**ADDENDUM NO. 1**

**CID 01-STILLHOUSE BRANCH WASTEWATER TREATMENT FACILITY  
IMPROVEMENTS**

**PROJECT NO.: 2-01590 | TWDB CWSRF NO. 73776**

**DATE OF ADDENDUM: MAY 24, 2023**

ADDENDUM #1	5-23-23
REV. DESCRIPTION	DATE
<b>CITY OF GATESVILLE</b>	
CITY OF GATESVILLE - STILLHOUSE WWTF UPGRADE AND EXPANSION	
<b>YARD PIPING PROFILES - LINE E</b>	
5-8-23	MICHAEL CLOUGH
DATE	DESIGNED BY J. JENKINS
	DRAFTED BY M. CLOUGH
	CHECKED BY J. JENKINS
	PROJECT NO. 2-01590
	DRAWING NO. C-12

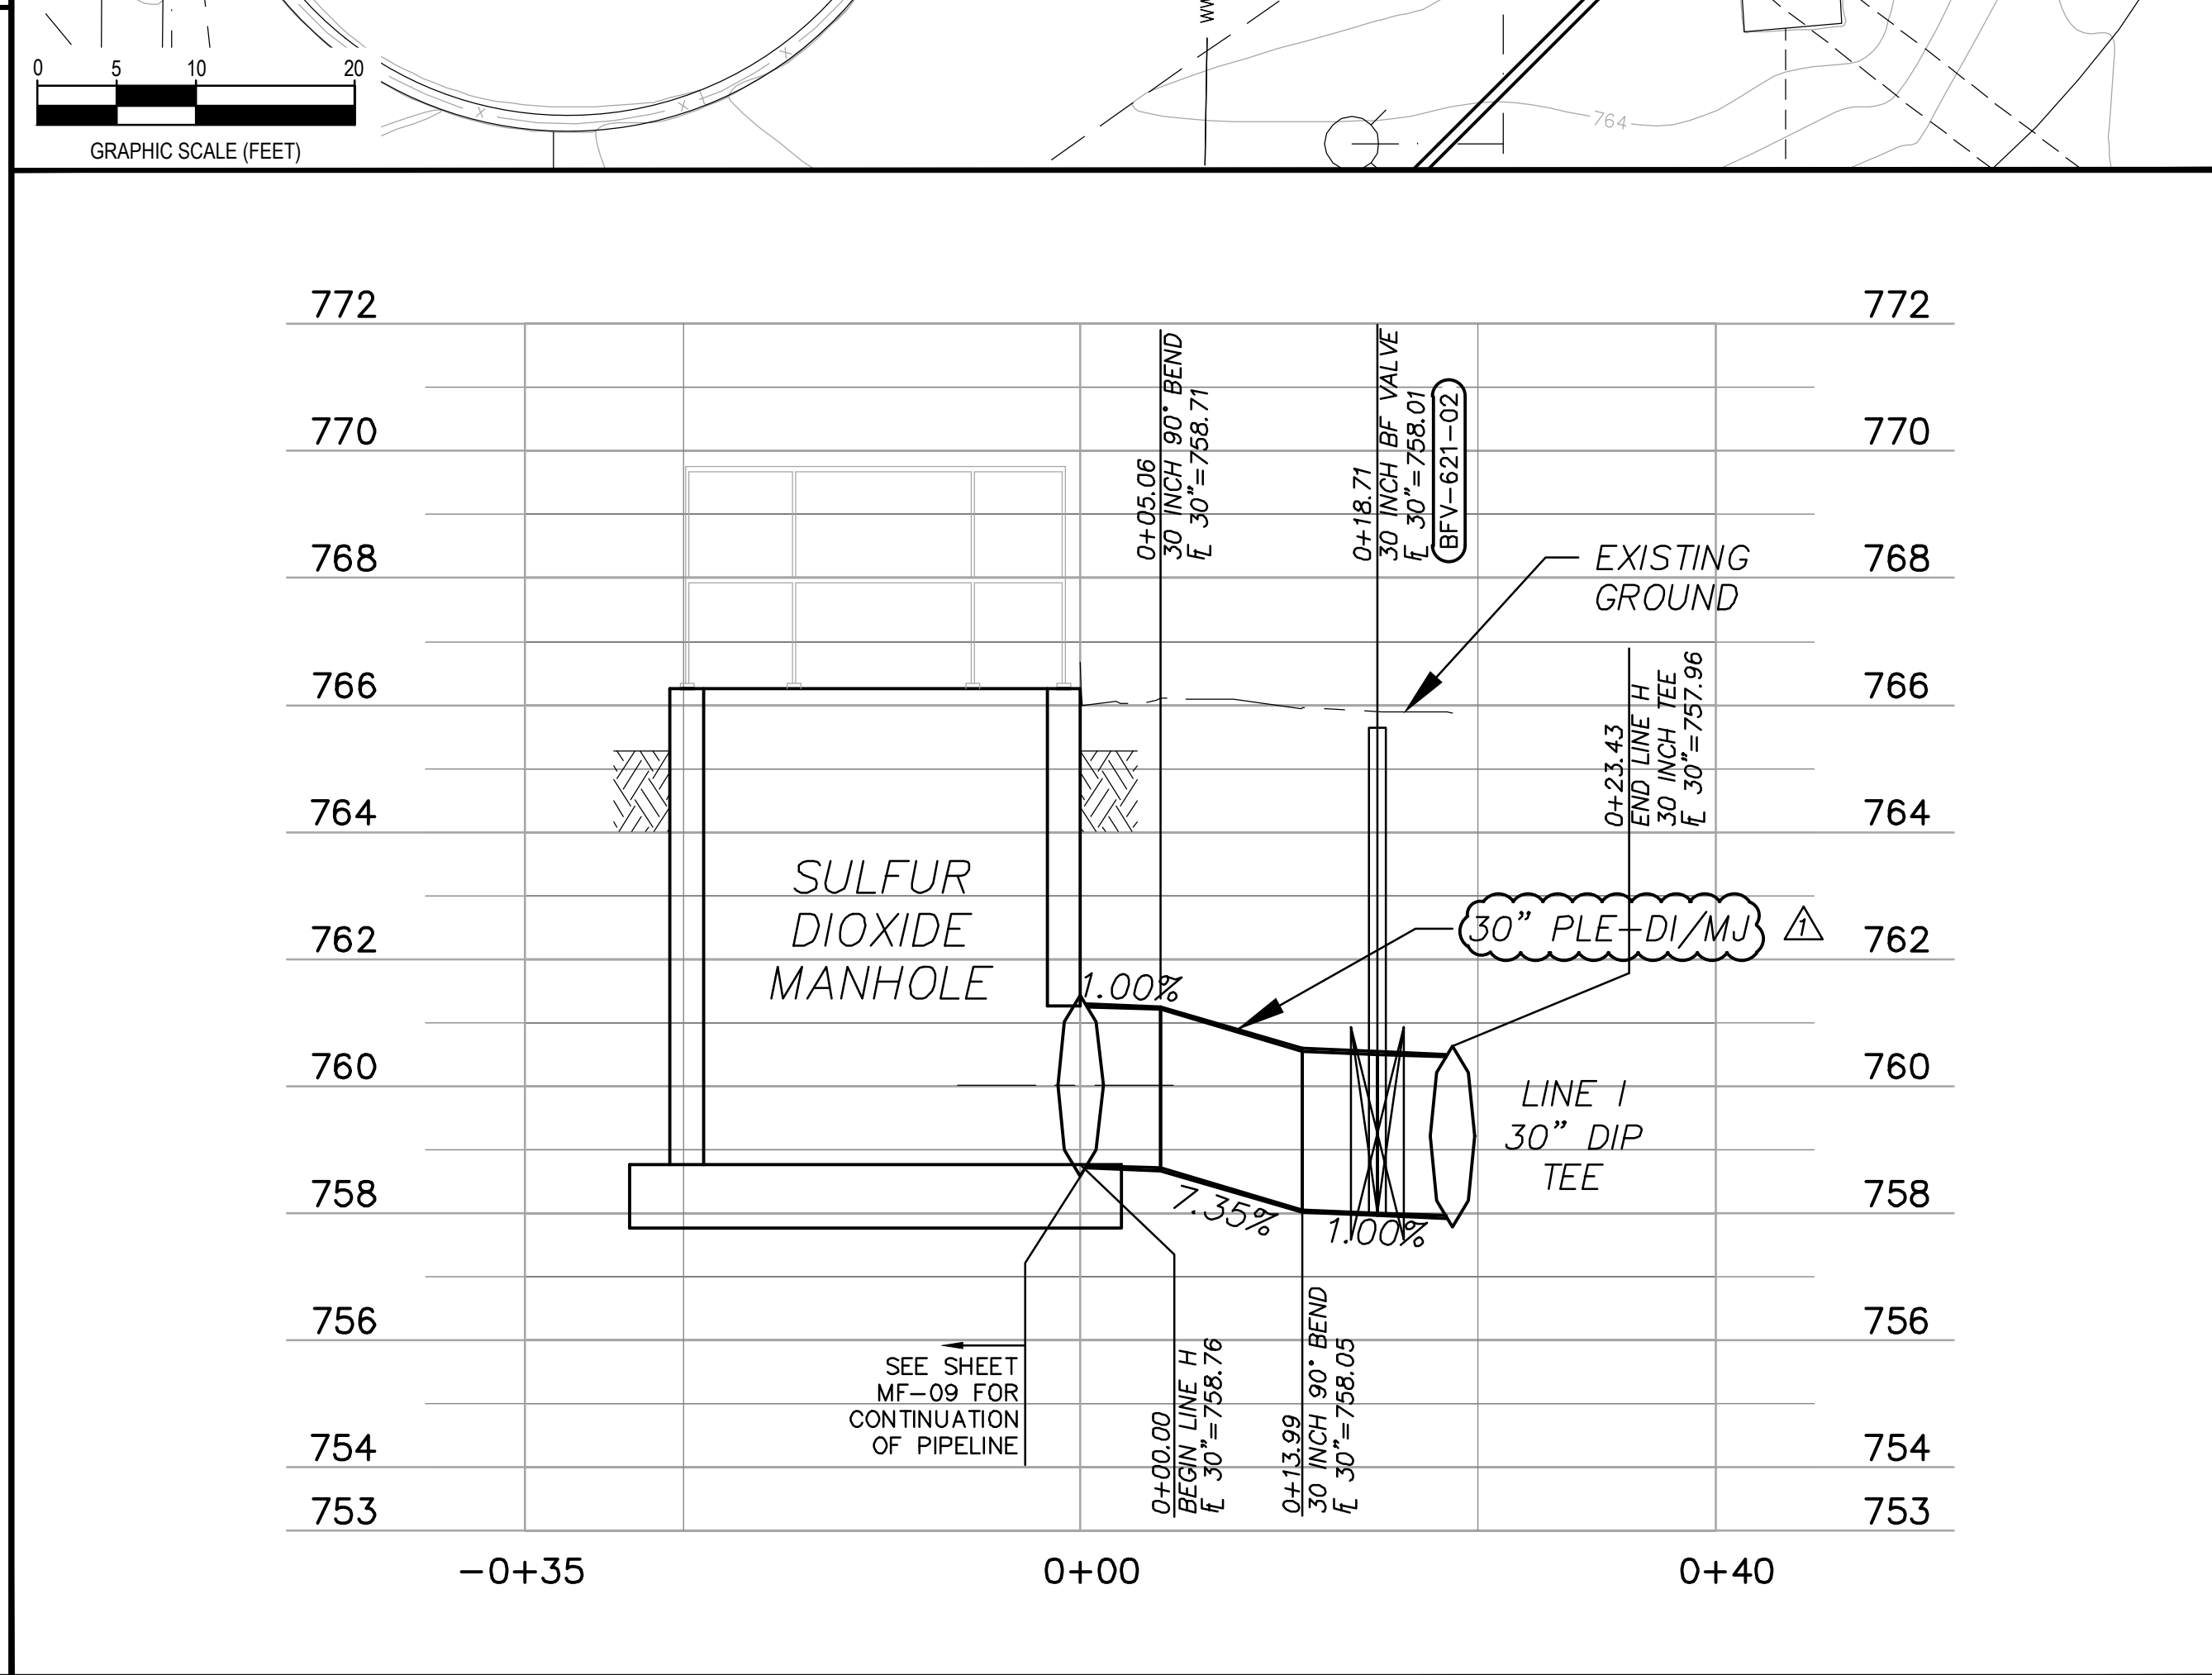
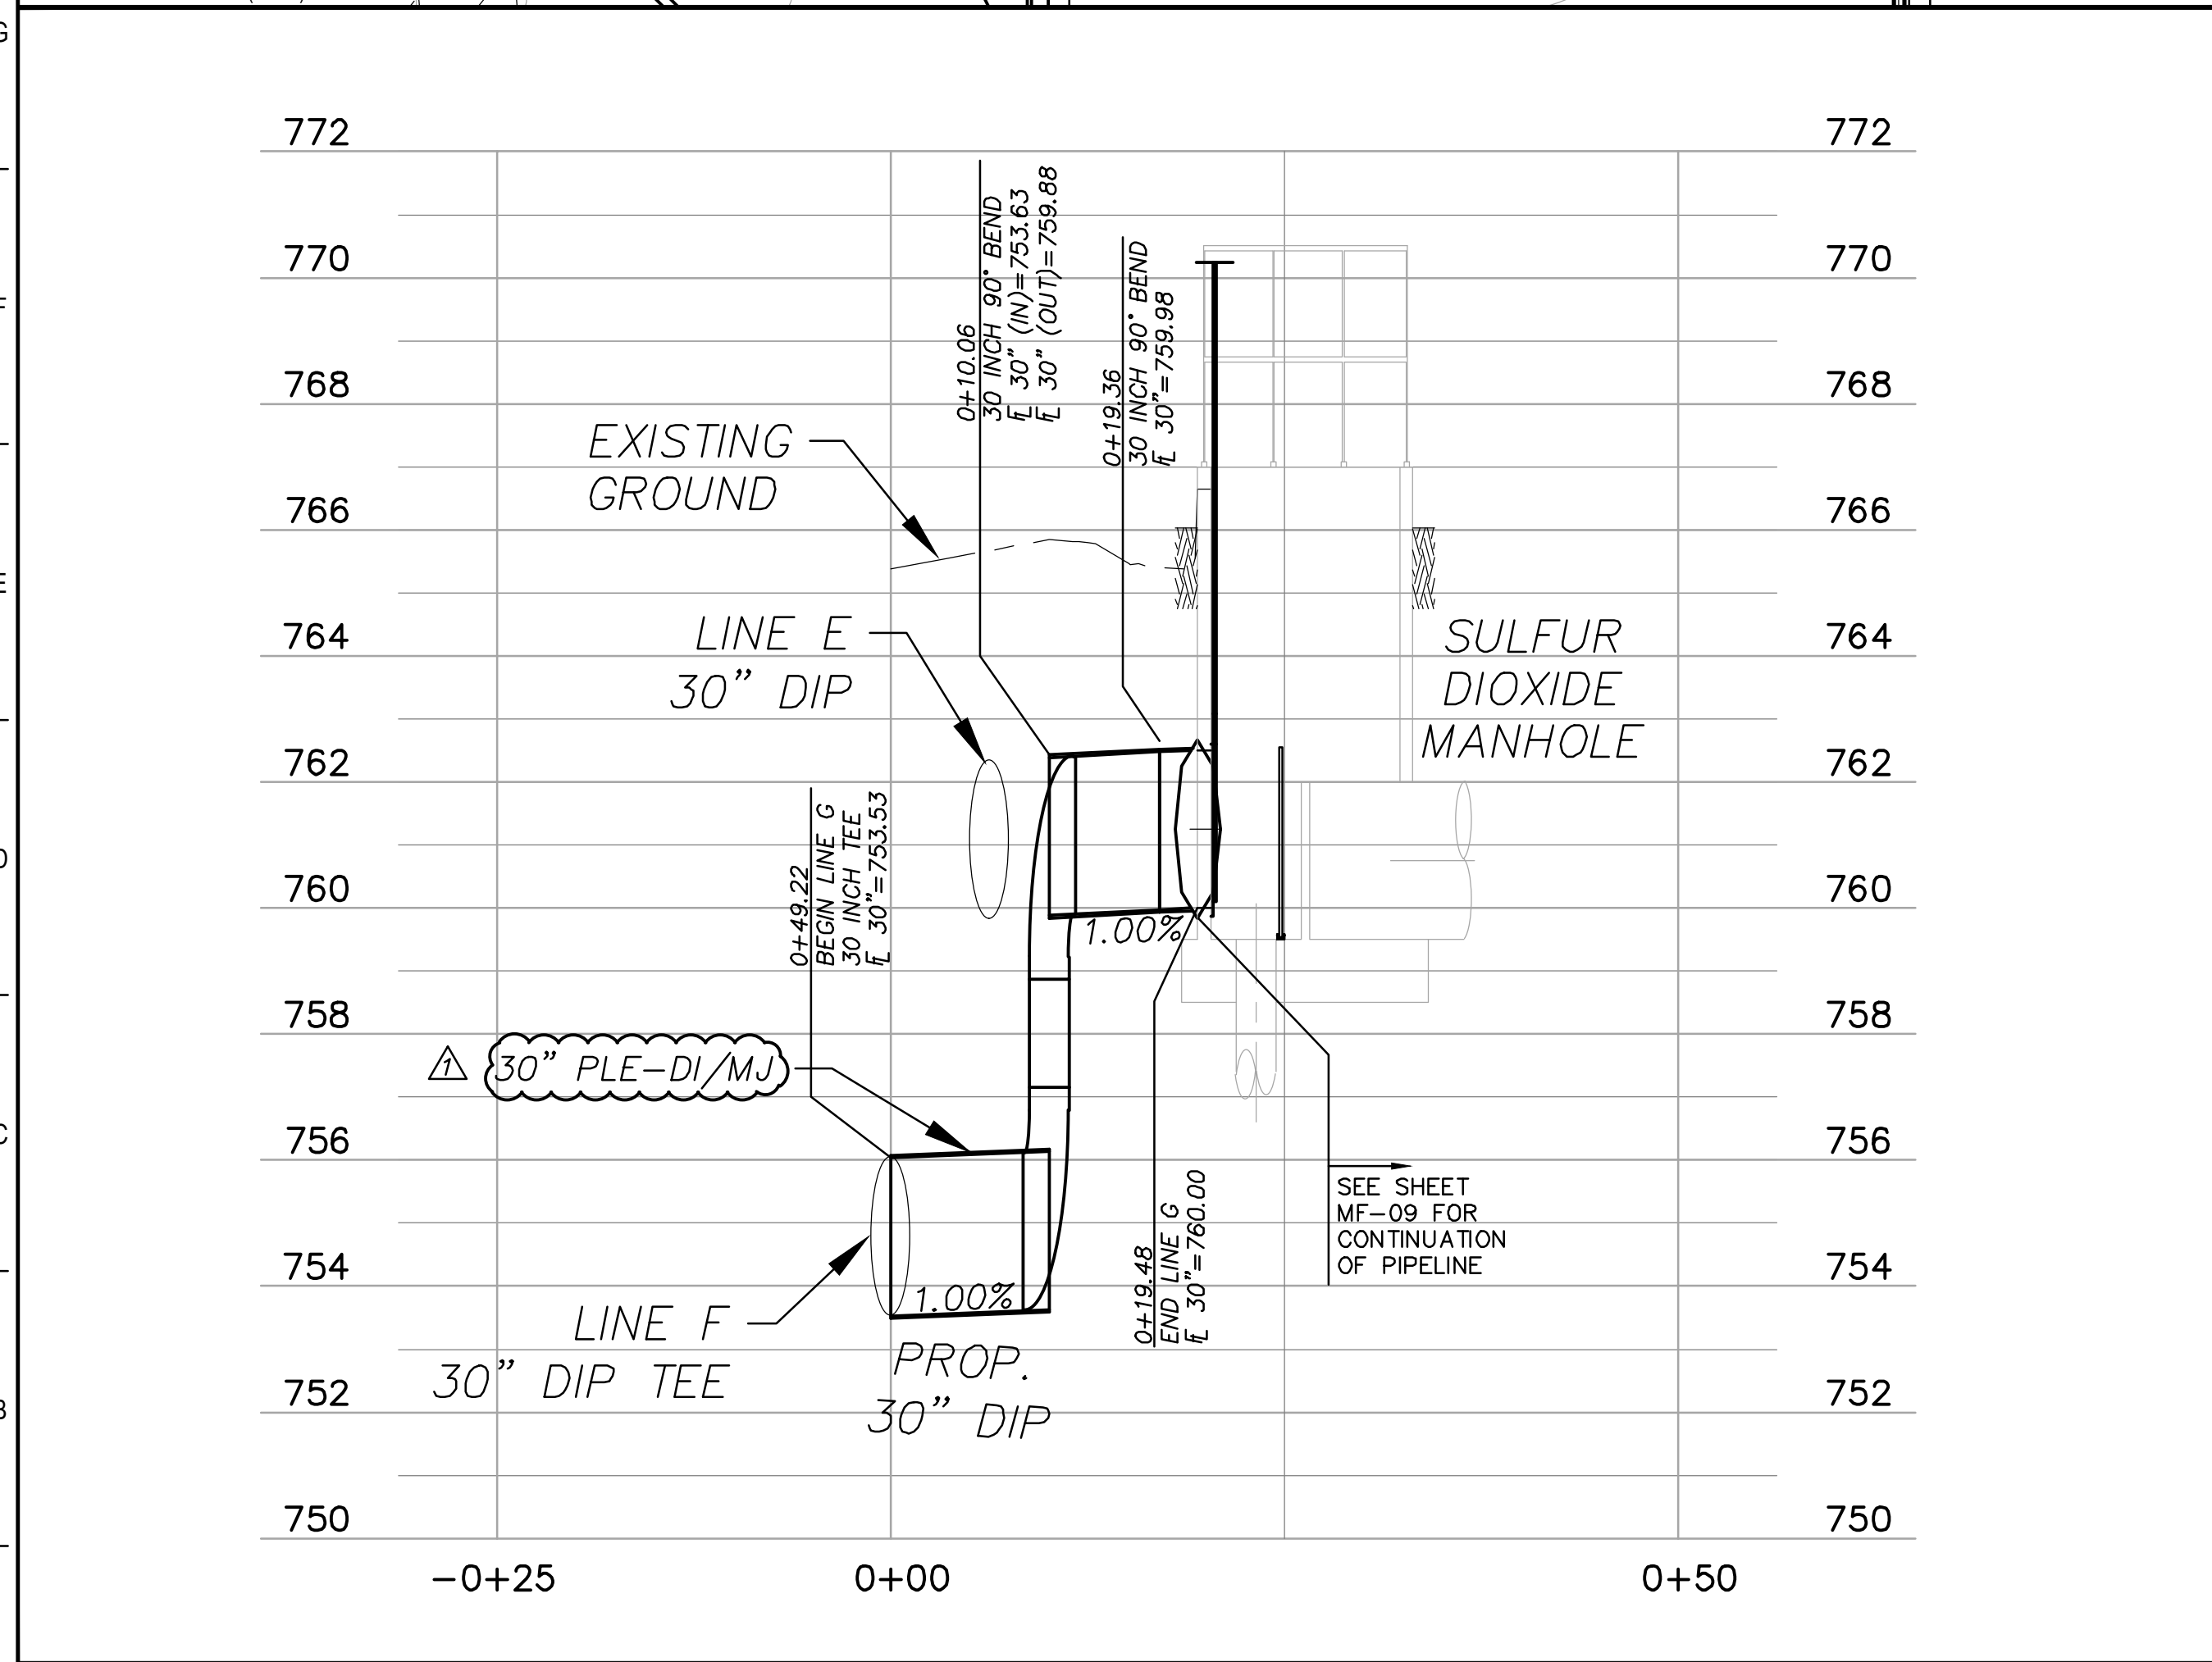
a. Sheets C-08 through C-17

REVISE yard piping to reflect the pipe labels on Sheet M-01 and Sheet M-02.
